Item ID: D350-607-511 Accept ***N900040100*** Setup Start ***NS1***
 Revision ID: Stop ***NS2***
 Item Name: Quick Release Basket and Long Cargo Tube Mounting Provisions, Fits LH or RH
 Start Date: 3/16/2016 Start Qty: ~~2.00~~ ***2*** 5 ***5*** Cust Item ID:
 Required Date: 3/18/2016 Req'd Qty: 2.00 Customer:
 Reference:

DART SERVICE INSTRUCTION

TO AMEND INSTALLATION INSTRUCTIONS D350-607-3 Rev.D,
INSTALLATION INSTRUCTIONS D350-607-4 Rev. C AND
INSTRUCTIONS FOR CONTINUED AIRWORTHINESS ICA-D350-607 REV. 6
REF TCCA STC: SH94-14
REF FAA STC: SR00213NY
REF EASA STC: EASA.10016996
REF BRAZILIAN STC: 2007S03-03/-04/-05/-06

A	NEW ISSUE	AJS	14.05.16
REV.	DESCRIPTION		BY DATE
DESIGN	AJS	DART AEROSPACE LTD HAWKESBURY, ONTARIO, CANADA	
DRAWN	AJS		
CHECKED		DRAWING NO.	REV. A
MFG. APPR.	N/A	DSI 9699	SHEET 1 OF 2
APPROVED		TITLE	SCALE
DE APPR.		LUG REPLACEMENT	NTS
DATE	14.05.16	COPYRIGHT © 2014 BY DART AEROSPACE LTD THIS DOCUMENT IS PRIVATE AND CONFIDENTIAL AND IS SUPPLIED ON THE EXPRESS CONDITION THAT IT IS NOT TO BE USED FOR ANY PURPOSE OR COPIED OR COMMUNICATED TO ANY OTHER PERSON WITHOUT WRITTEN PERMISSION FROM DART AEROSPACE LTD.

FIGURE 1: INSTALLATION OF D4775-041 FWD STRUT

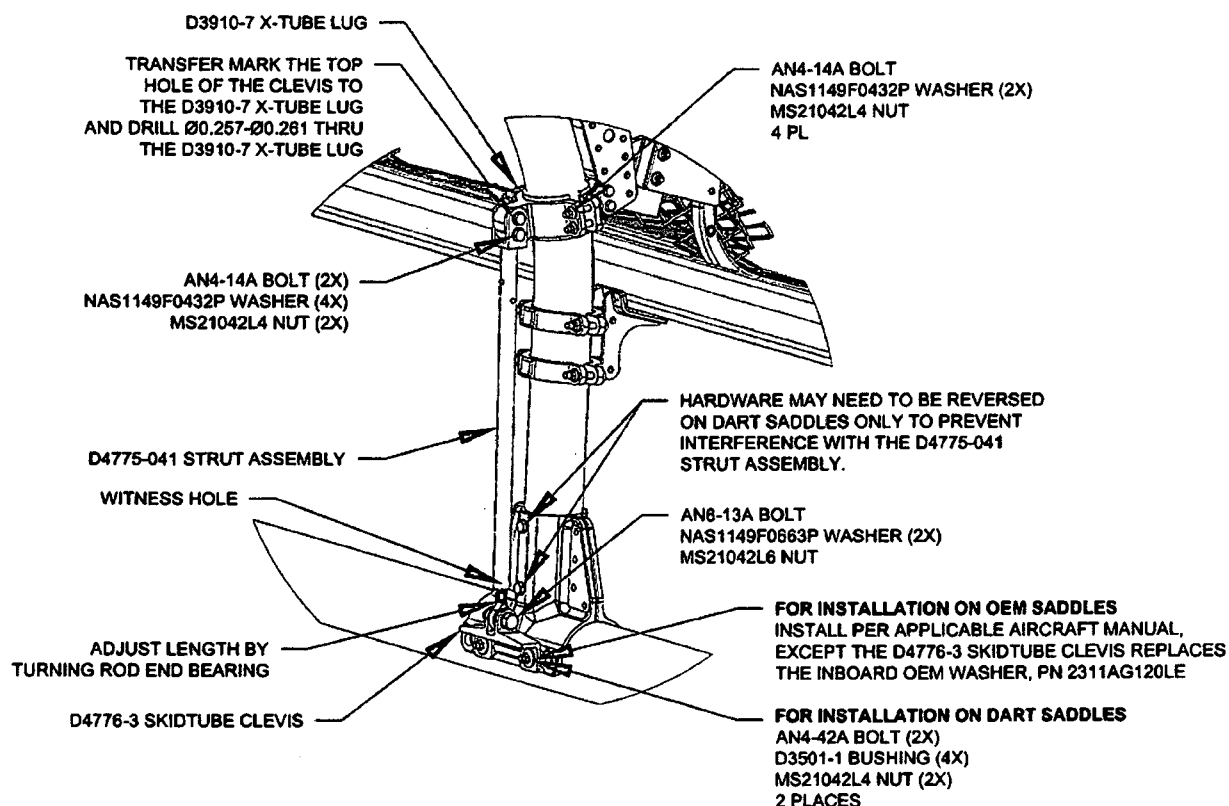
- 3.1 Substitute the Forward Lower D3910-5 X-Tube Lug with the D3910-7 X-Tube Lug as shown in Figure 1.
- 3.2 Install the forward D4775-041 Strut Assembly. Transfer mark from the upper hole on the clevis of the D4775-041 Strut Assembly to the D3910-7 X-tube Lug and drill thru the lug $\varnothing 0.257 - \varnothing 0.261$ as shown in Figure 1. Touch up chemical conversion coating per MIL-DTL-5541. Check the witness holes located at the bottom end of the D4775-041 Strut Assemblies to ensure that the thread from the rod end extends past the witness hole.
Torque MS21042L4/-4 nuts to 50-70 in-lbs (5.7-7.9 N-m). Torque MS21042L6/-6 nuts to 160-190 in-lbs (18.1-21.5 N-m).
- 3.3 Complete the installation in accordance with Installation Instructions D350-607-3 Rev. D or D350-607-4 Rev. C.
